Wollongong Local Planning Panel Assessment Report | 4 September 2019

WLPP No.	Item 2
DA No.	DA-2019/501
Proposal	Residential – demolition of existing dwelling and all associated structures and new dwelling house, retaining walls, swimming pool, terrace, front fence and driveway
Property	61 Lawrence Hargrave Drive, AUSTINMER, NSW, 2515 Lot 2 DP 1119139
Applicant	Elmwood Homes Pty Ltd
Responsible Team	Development Assessment and Certification – Building and Certification Team (TB)

ASSESSMENT REPORT AND RECOMMENDATION

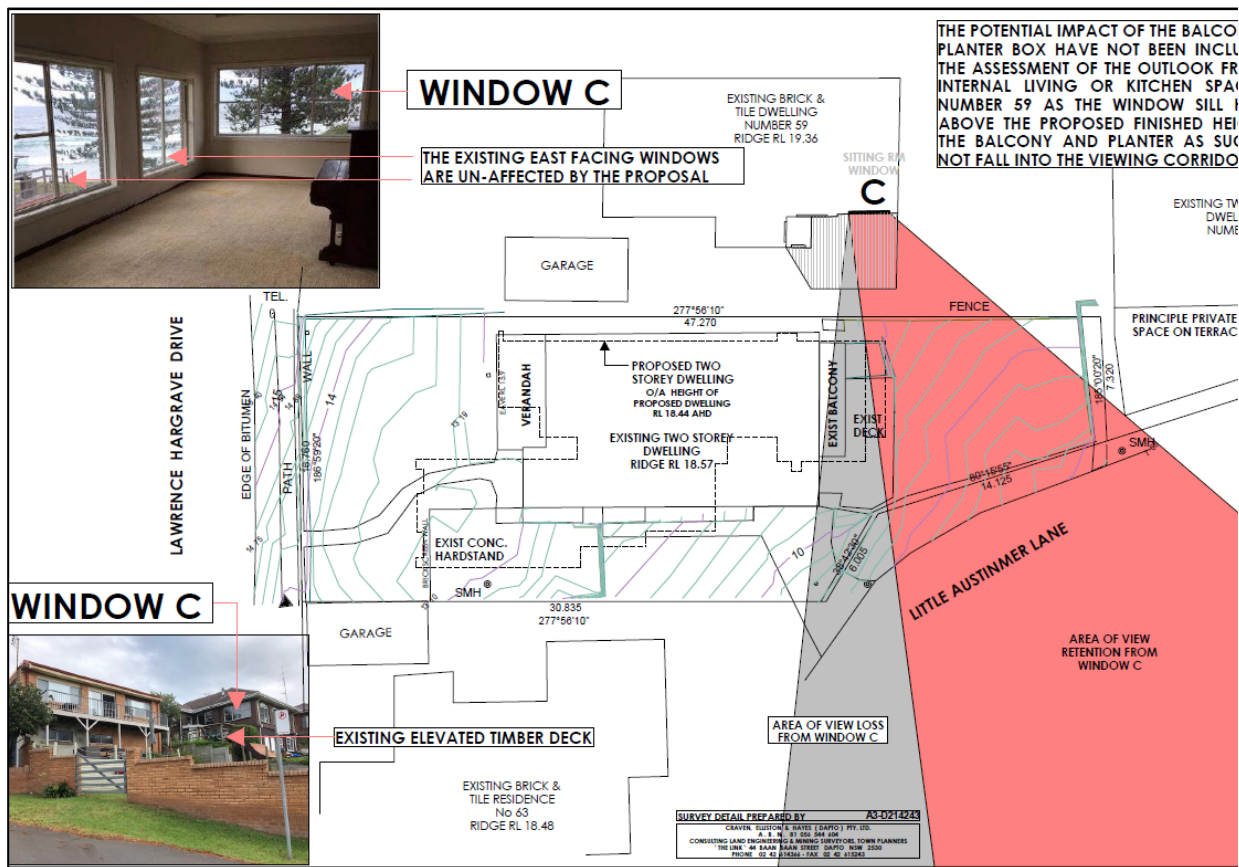
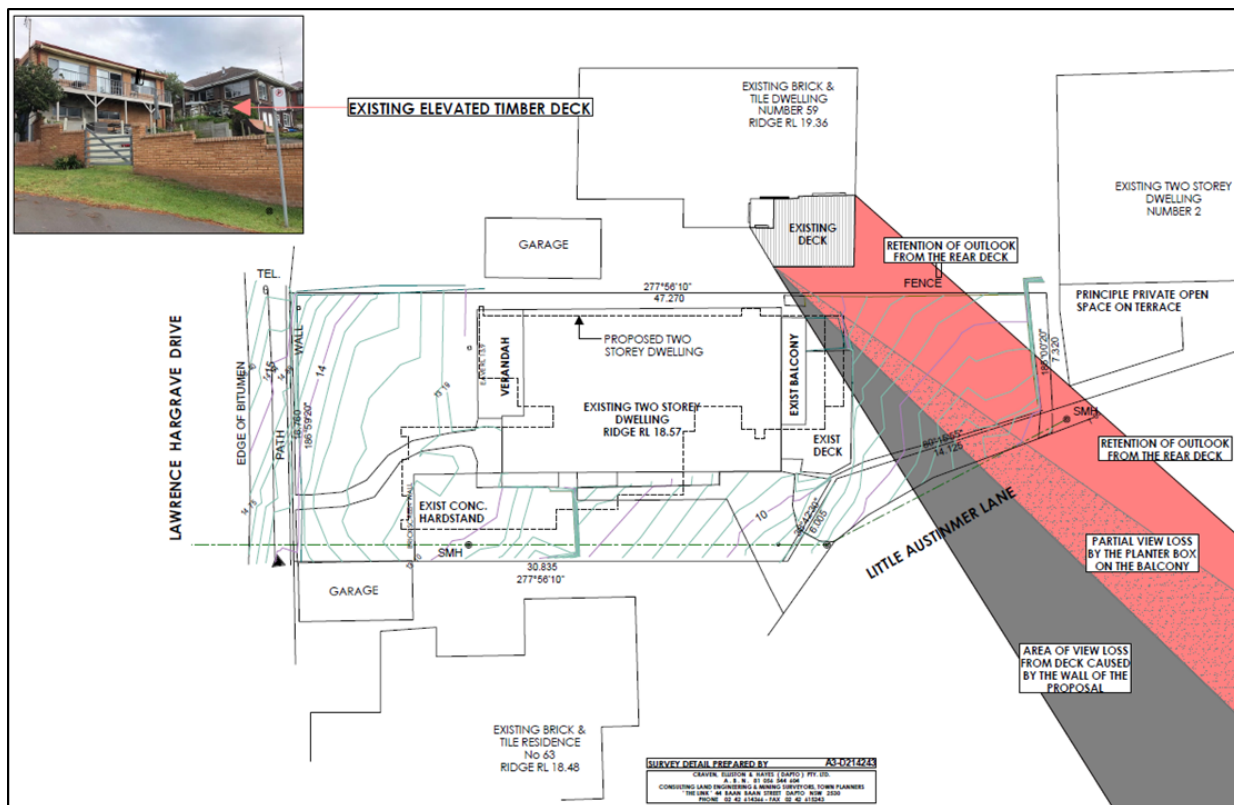
The Tenacity Principles state the assessment of the impact of the proposal should be undertaken for the whole property, not just the views that are affected. The impact on views from living areas is more significant than from bedrooms or service areas. In this instance, the design of No. 59 has been focused around the coastal views to the south from the kitchen, dining room, sunroom/living room and deck. The following images show an approximate outline of the proposed development and its approximate impact on views from No. 59. It should be noted that the approximate placement and height of the staff was measured prior to the amendment made on the plans that identify the reduced width of the balcony and the removal of the privacy screen. The images below are an **estimate** to the height and location of the amended balcony and dwelling, and do not include the single storey portion of the dwelling.

In this instance, using the above view analysis the view impact is considered to be ***'moderate'***. This is due to the main view being impacted is from a service area, and views being partially maintained from the dining room and partially maintained or not impacted from the sunroom/living room and deck.

As mentioned previously, the plans have since been amended so that the second storey privacy screen has been removed, and that the balcony width reduced from 1.8m to 1.2m to allow for views to be retained over the balustrade.
